#305392 DRIVE SHAFT PIN 2 X 10 WITH FLAT SPOT (2)

USING PINS WITH FLAT SPOTS IN THE CVD SHAFTS

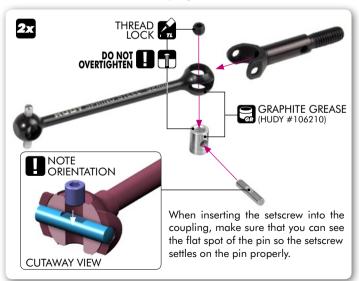
To help prevent of loosening of the setscrew from the CVD shaft, XRAY recommends using these new pins with flat spots. The flat spots allow the setscrew to better settle into the coupling.
